mb-microtec

October 3, 2019

RE: NRC RAI Dated September 17, 2019

Enc.: Drawings of hands with 4 GTLS's

Abbildung 1 M-hand with 2x2 trigalights (hairlight)

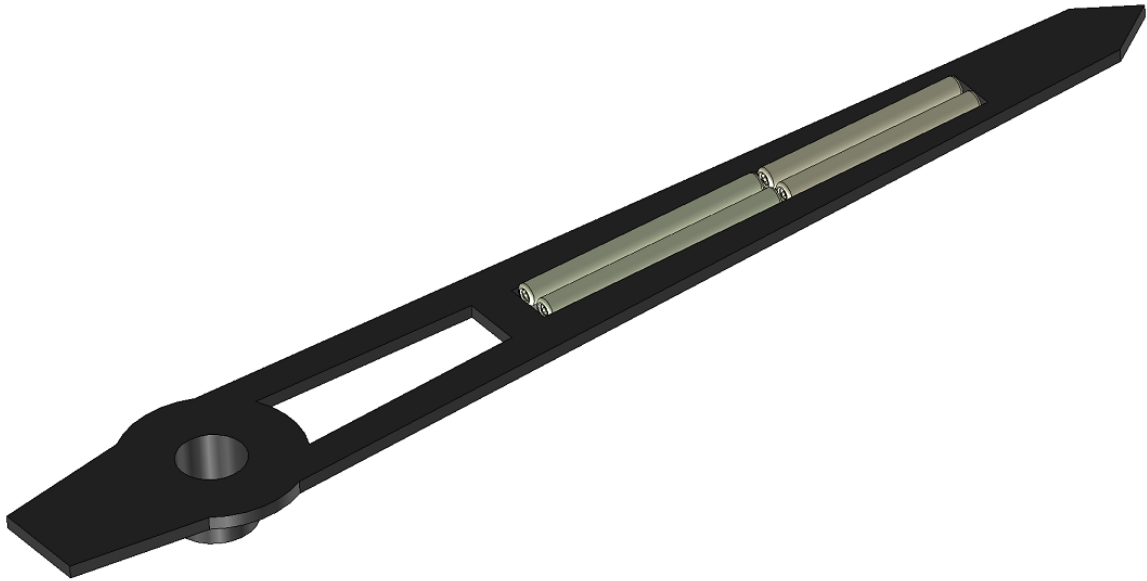
In your amendment request, you indicated that new watch models may contain up to 4 gaseous tritium light sources (GTLS) per hand. Please provide drawings of the watch hands for those watch models that use up to 4 GTLS.

Drawings of the hands with 4 GTLS's are included with this response.
